**AGENDA**  
**PLANNING AND ZONING COMMISSION WORK SESSION**  
**City Hall, 385 South Goliad, Rockwall, Texas**  
**Council Chambers**  
**June 25, 2019**  
**6:00 P.M.**

**MINUTES**  
**PLANNING AND ZONING COMMISSION WORK SESSION**  
**City Hall, 385 South Goliad, Rockwall, Texas**  
**Council Chambers**  
**May 28, 2019**  
**6:00 P.M.**

**planting requirement**

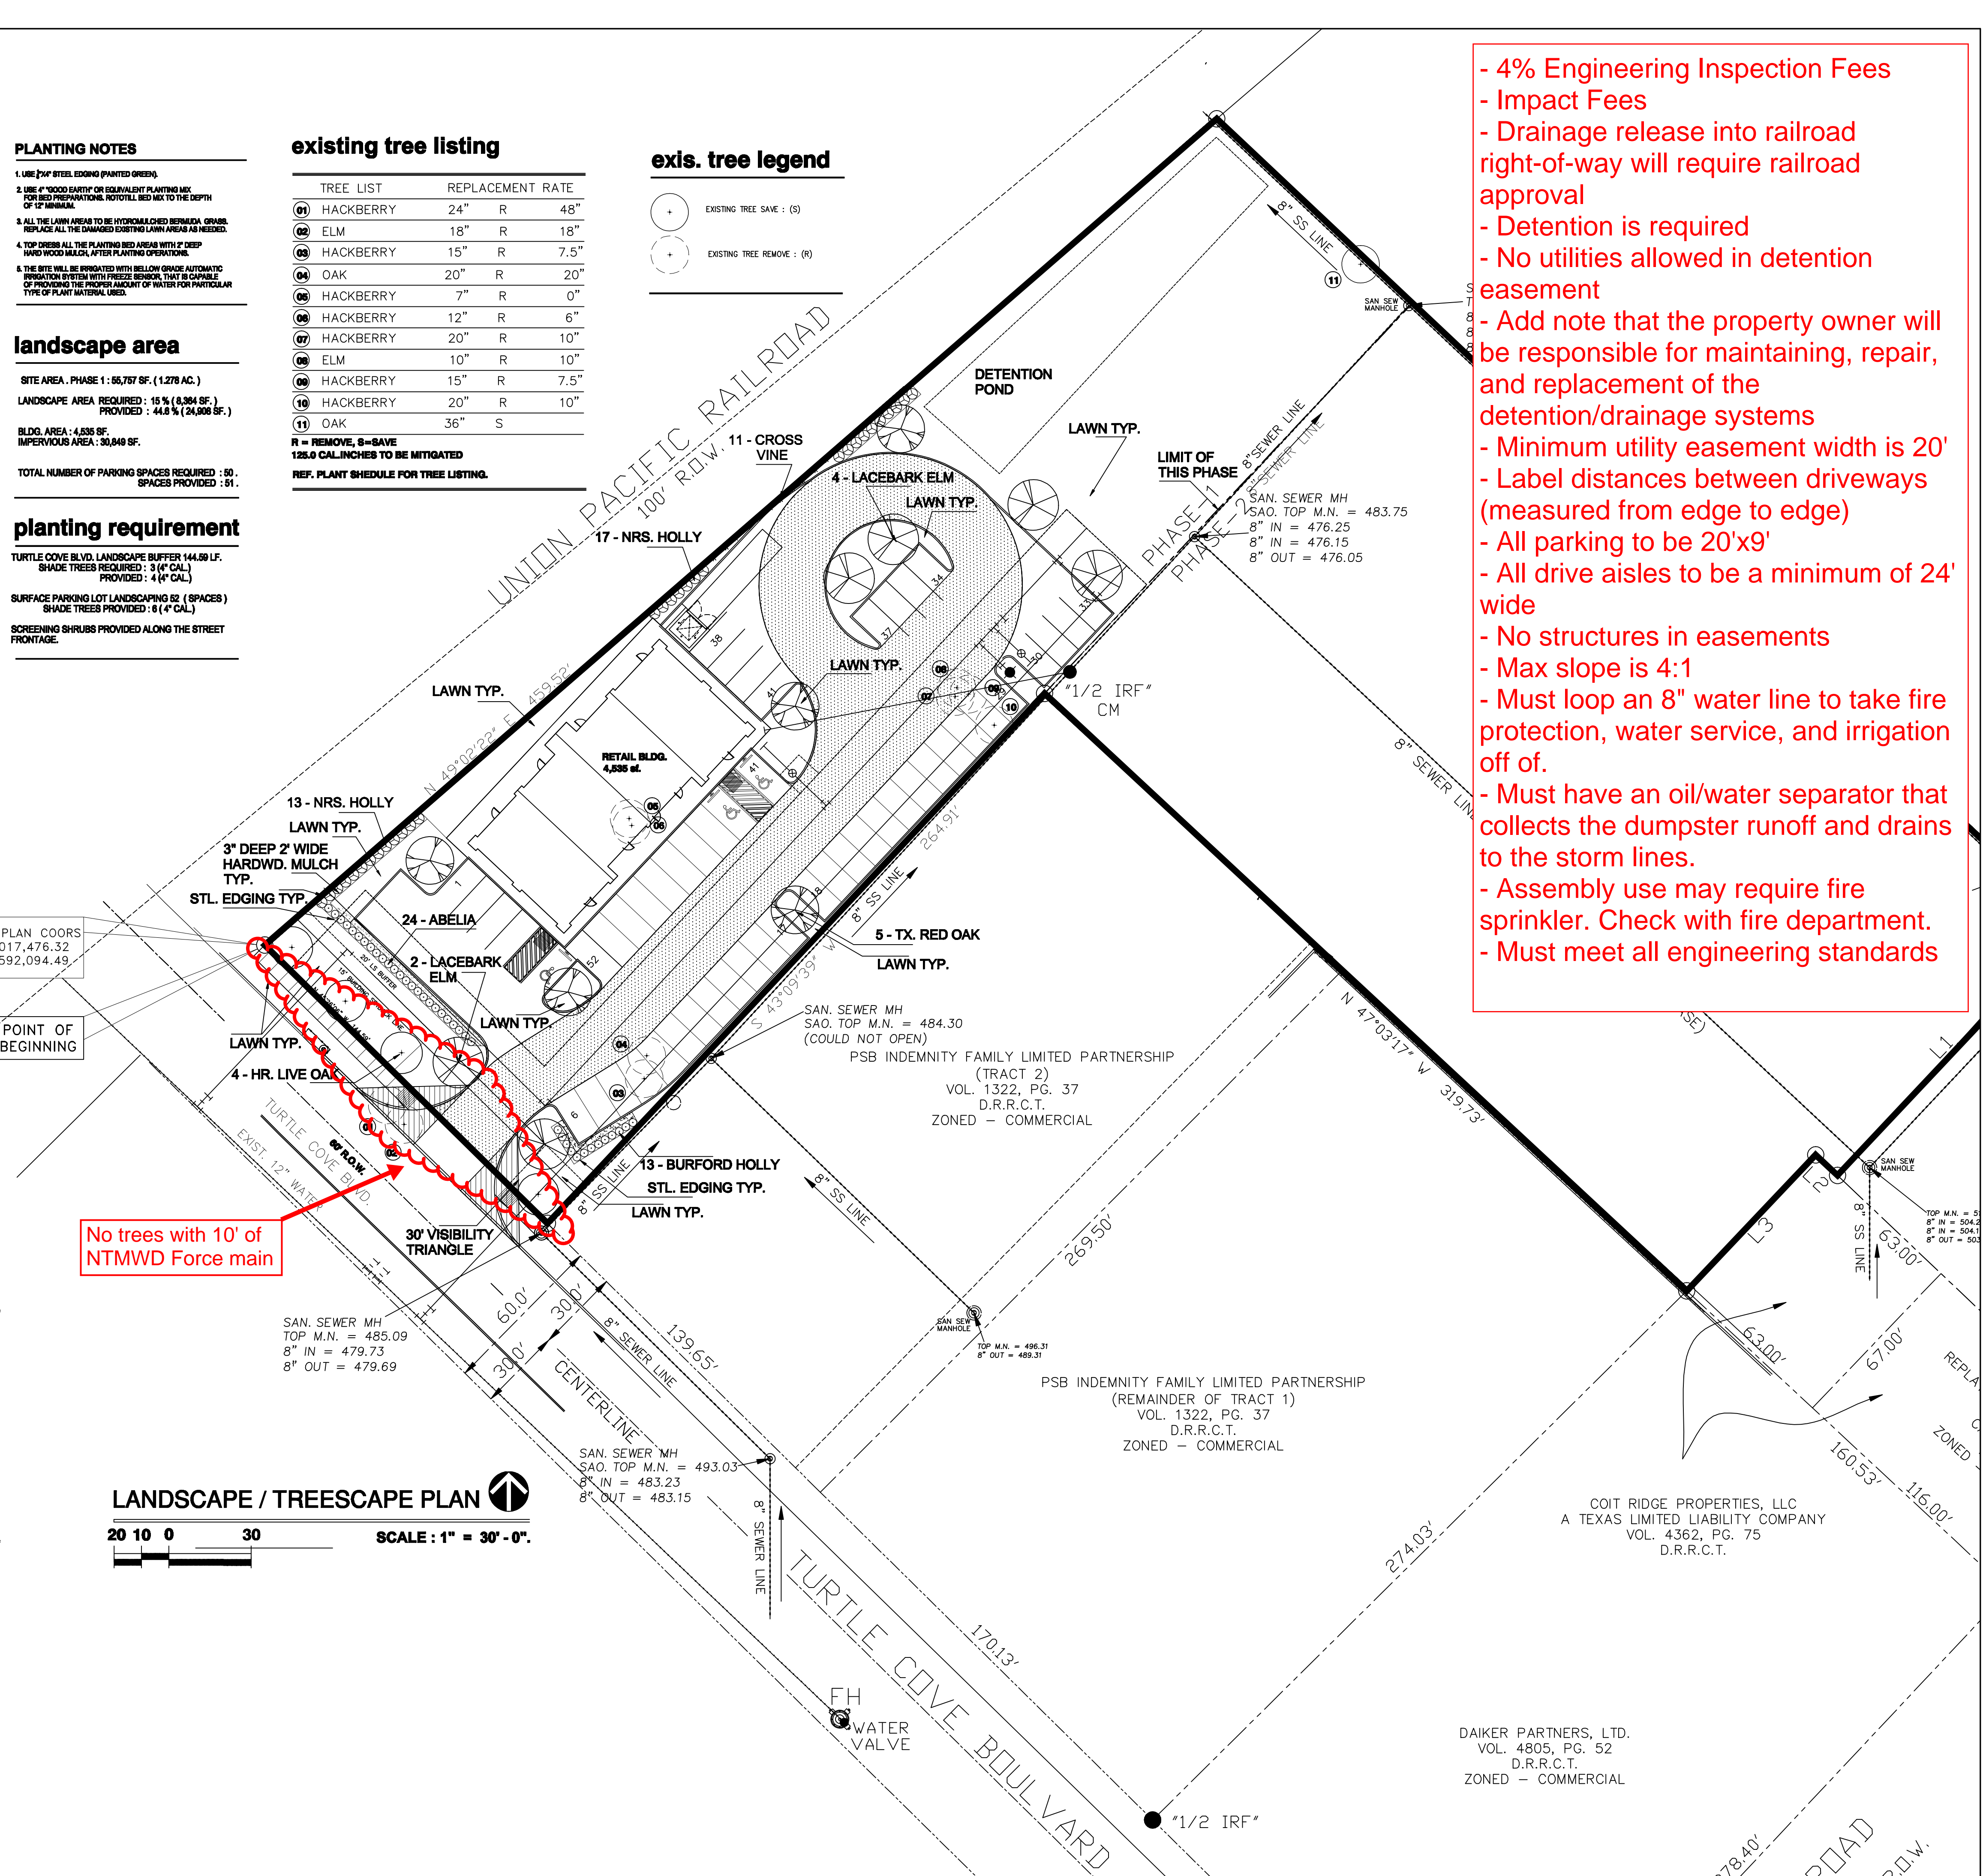
Type of Review / Notes	Contact	Sent	Due	Received	Elapsed Status	Remarks
28.	Sheet LP.01					—please dimension a typical parking space—also as noted, parking must be 9x20.

29.	Sheet LP.01					—The parking and building can be greyscaled so that the landscape plan focuses on the landscaping.
30.	Sheet LP.01					—Please note that the landscape buffer is 20-feet and the building setback is 15-feet.

31.	Sheet LP.01					—Please provide the actual footprint of the building (i.e. show any projections or recesses).
32.	Sheet LP.01					—Please provide adjacent property information as shown on C-1.

33.	Sheet LP.01					—Please darken and label property line for subject property.
34.	Sheet LP.01					—There several dashlines toward the SE of the property that are not labeled. Please label all lines, provide a variety of lineweights/types. A legend can be provided in lieu of labeling each line. As drawn, the utilities and property lines, ROW, etc. have the same line weight and type.

35.	Sheet LP.01					—There are several dark circles with a line projecting and several open circles. Please label or provide a legend.
36.	Sheet LP.01					—As on Sheet C-1, please show firelane as a shade of grey and any remaining concrete as a lighter shade of grey. Please use the stippling pattern currently being used on the firelane to show where grass will be.

37.	Sheet LP.01					—Please add site data table as mentioned above. Some of the needed information is already being provided on the sheet; however, please replace with the same data table so that all sheets have the same data table/same information.

38.	Sheet LP.01					—Please darken visibility triangles
39.	Sheet LP.01					—What are the two hatched areas at the end of the parking toward the rear of the building?

40.	Sheet LP.01					—For consistency purposes, please change title from Planting Plan to “Landscape/Treescape Plan”
41.	Sheet LP.01					—Please note that the min caliper inch for trees is 4-inches.

42.	Sheet LP.01					—Please note that headlight screening may be required along the property line adjacent to the RR.
43.	Sheet ESP					—Please removed the details of the light pole. Just show the pole from the ground up and provide height.

2 SOUTH ELEVATION  
 SCALE: 1/4" = 1'-0"

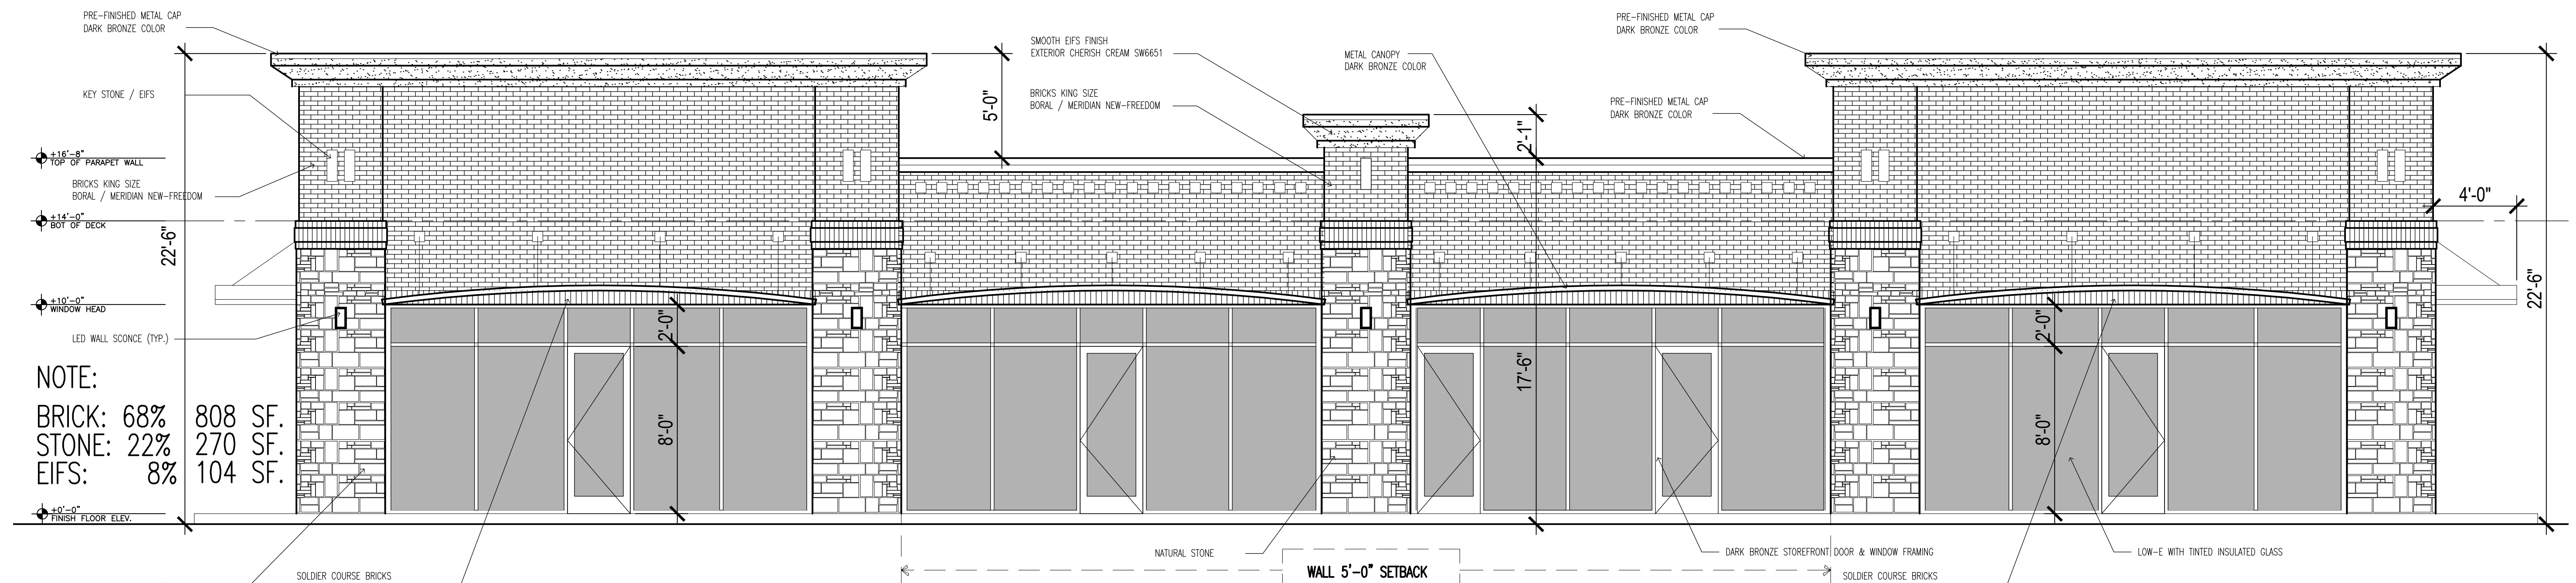
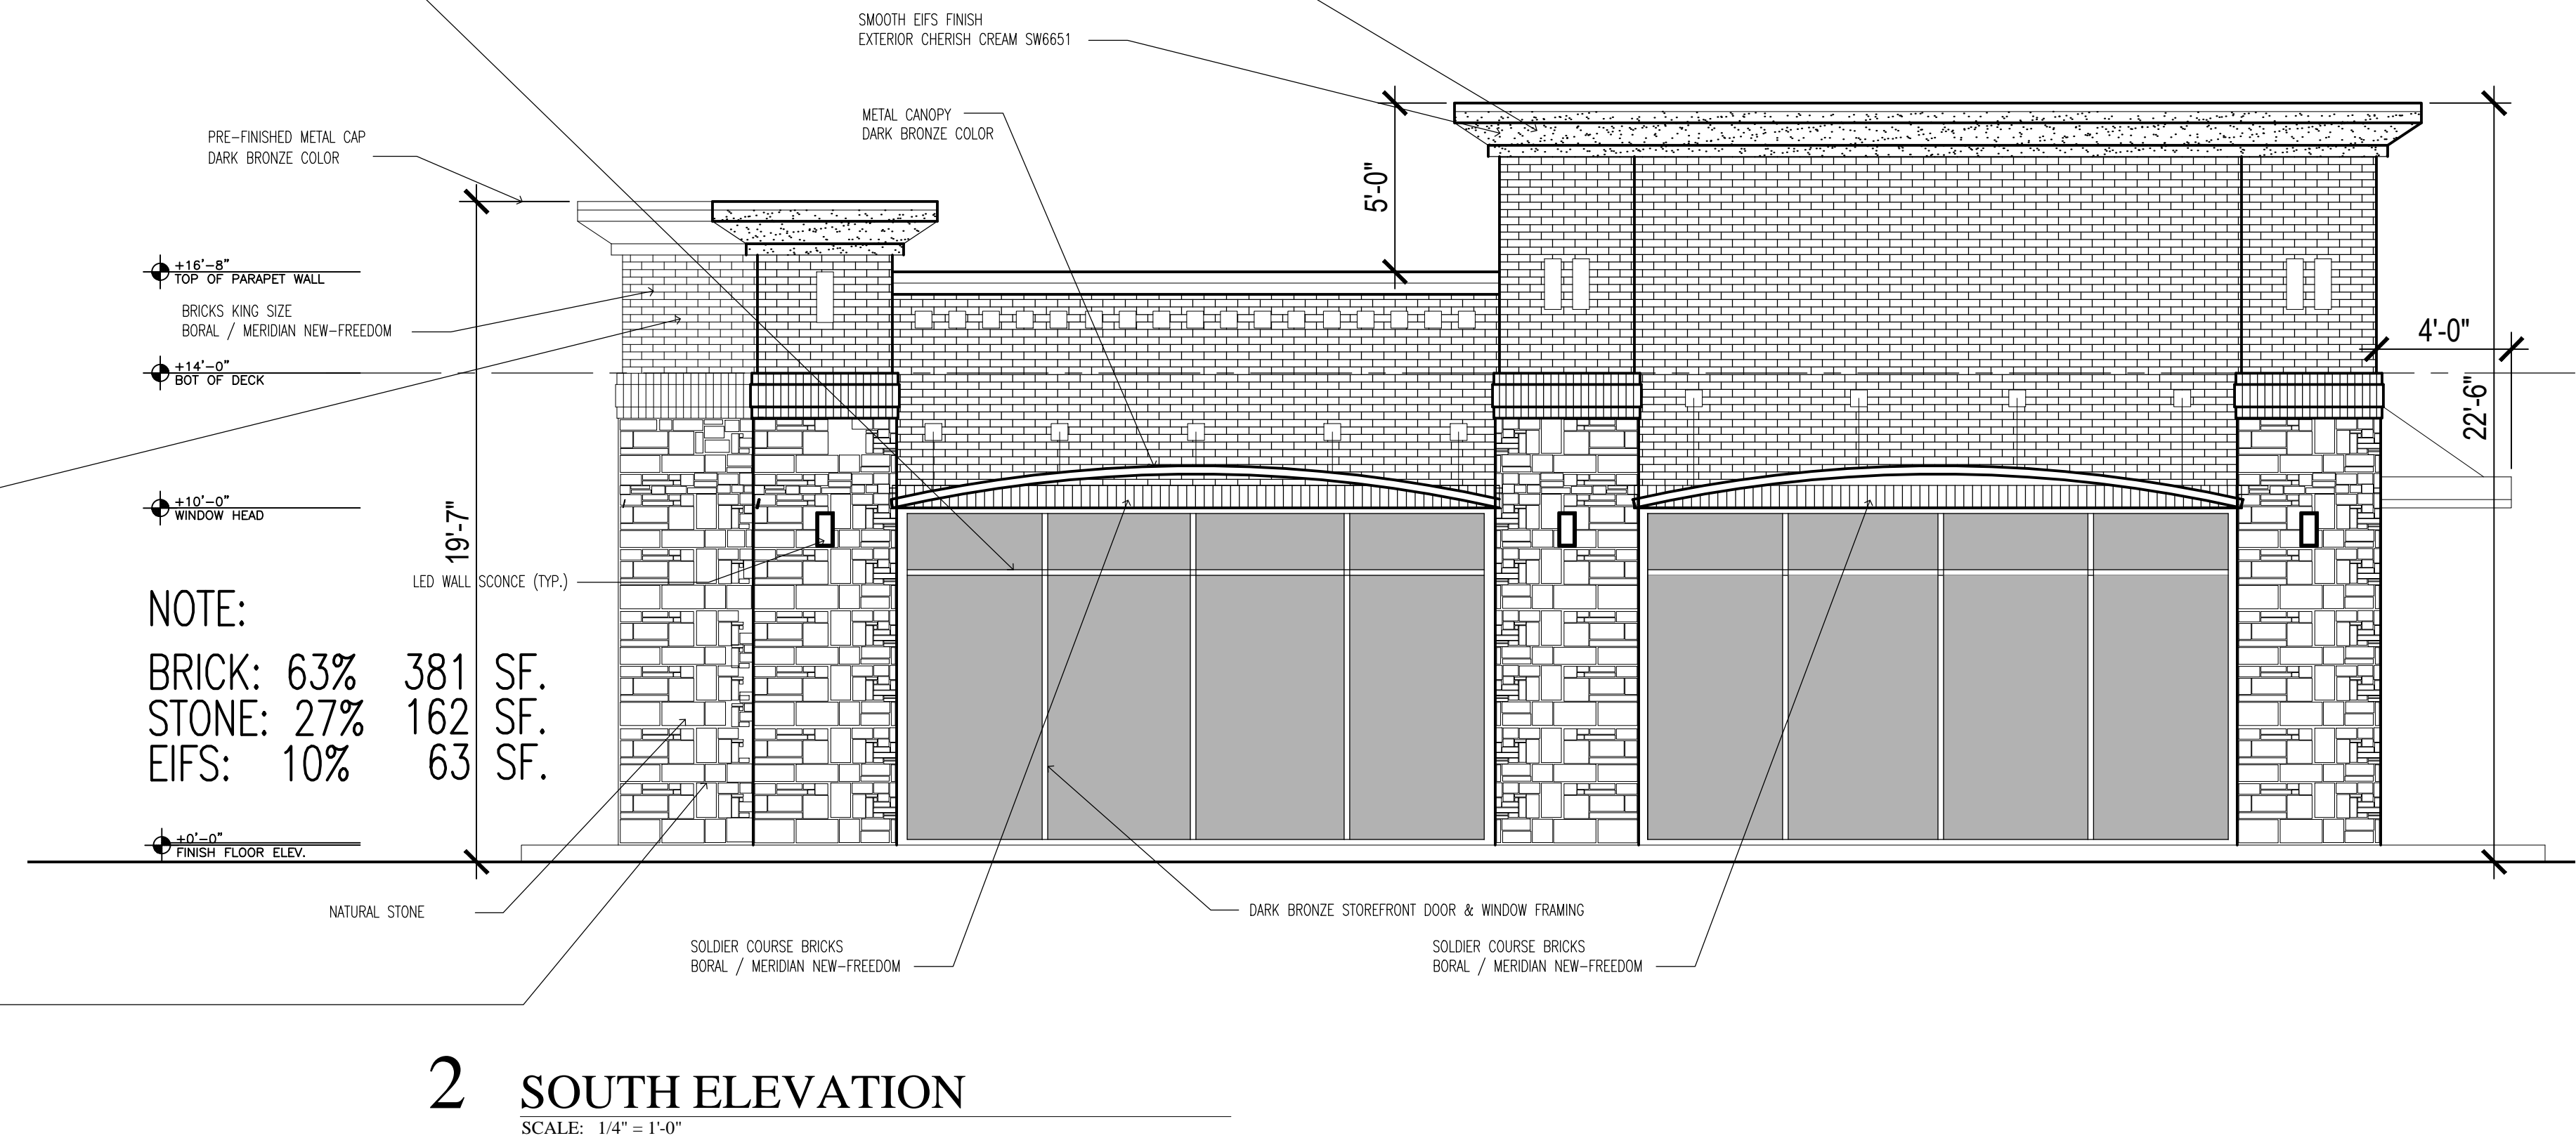
56.	Sheet A501					—Please remove all signage.
57.	Sheet A501					—Please add cardinal direction to all elevation.
58.	Sheet A501					—Please provide height of “tower element” closest to the building material percentage on elevation 2 and the element directly below on elevation 1.

59.	Sheet A501					—Please provide site data table.60. Sheet A501—Are the tower elements flush with the façade or do they project?
61.	Sheet A501					—Please note, as shown, the building elevations will require a variance to 4-sided architecture, and vertical and horizontal articulation.

62.	Sheet A501					—Please note that all buildings shall be architecturally finished on all 4 sides with the same elements and materials.
63.	Sheet A501					—Please note that elevation 1 exceeds the max of 10% EIFS—this will require a variance.

64.	Sheet A501					—Please label the material above the window as provide type of material for awnings.
65.	Sheet A501					—Please provide elevation of dumpster enclosure.

Type of Review / Notes	Contact	Sent	Due	Received	Elapsed Status	Remarks
66. Sheet A501—Please dash-in all rooftop equipment and provide information on how it will be screened.

67. Please label at least one set of light fixtures on each of the elevations.						
68. Sheet A501—What material is the small squares on the building elevations?

69. Sheet A501—is the stone a natural stone?						
70. Sheet A502—Please note that the two elevations are labeled the same as the elevations on A501.
